Subject: Docket Number 070-03098
Duke Cogema Stone & Webster
Mixed Oxide Fuel Fabrication Facility
Construction Authorization Request
Clarification of Responses to NRC Request for Additional Information

Enclosures: A. Responses to NRC Clarification Requests
B. Natural Phenomena for MFFF Design

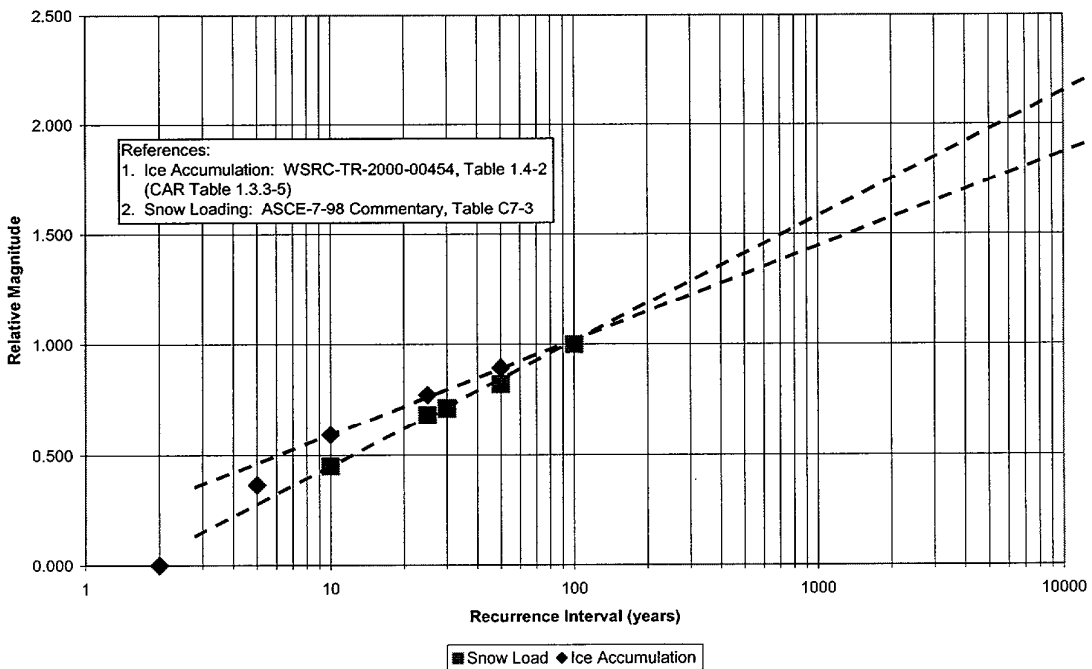
In response to RAI 56, DCS stated that it selected a 100 year recurrence interval for snow loading. Chapter 1 in the CAR states that a 100 year recurrence interval snow load corresponds to 5 pounds per square foot (psf). NRC staff requested that DCS consider a snow load recurrence interval for more than 100 years (i.e., on the order of 10,000 years). Since the larger snow load is an extrapolation of snow loads having a lower recurrence interval, NRC staff also questioned whether the appropriate 100 year snow load should be 5 psf or 10 psf, since the MOX site lies on a boundary in the map included in the American Society of Civil Engineers (ASCE) Standard 7-98 Figure 7-1, "Ground Snow Load for the United States."

DCS stated that it had considered a larger recurrence interval and that the snow load associated with this larger interval is bounded by the roof load chosen for design. DCS will provide information to support this statement. DCS provided a more accurate map

showing that the MOX site lies in the 5 psf snow load zone in ASCE 7-98. NRC staff acknowledges that for the MOX site, the ASCE 7-98 Figure 7-1, "Ground Snow Load for the United States," shows that the snow load to be considered is 5 psf. {28 February 2002, item 2D}

As stated in Section 1.3.3.3 of the CAR, the maximum ground snow load for the SRS area for a 100 year recurrence period is estimated to be 5 psf. The source of this information is ANSI A58.1-1982, *Building Code Requirements for Minimum Design Loads in Building and Other Structures*, the predecessor to the current ASCE-7-98, *Minimum Design Loads for Building and Other Structures*. A review of Figure 7-1 in ASCE-7-98 shows that the ground snow load for the SRS is 5 psf for a 50-year mean recurrence interval. Converting this value to a 100-year mean recurrence interval using the factors shown in Table C7-2 results in an estimated ground snow load of about 6 psf. When this is combined with the estimated 3 psf ice loading described in CAR Section 1.3.3, the specified 10 psf combined ice and snow design basis loading for a 100 year recurrence period is still appropriate.

The information about relative magnitudes shown in the tables above is presented graphically in the figure below, showing the change in magnitude as recurrence interval changes. Extrapolations far out of the data range are likely to be extremely conservative. Global climate changes that would result in trends different than those shown will also take longer than the service life of the MFFF. These figures suggest that a 10,000-year event would be on the order of 1.8 (ice) to 2.2 (snow) times the 100-year event specified for MFFF design. Even if the 10 psf snow and ice design load were increased by this factor to represent a highly unlikely (extreme) snow and ice loads, its magnitude would still be bounded by the allowance (50 psf) for general live loadings, and would not control the MFFF design. Naturally, such extremely unlikely snow and ice loads would not be combined with general live loads from other sources.

To reflect the more recent estimate of snow load, the last sentence in the second paragraph of CAR Section 1.3.3.3 will be revised to read "The maximum ground snow load for the SRS area for a 100-year recurrence period is estimated to be 6 psf."
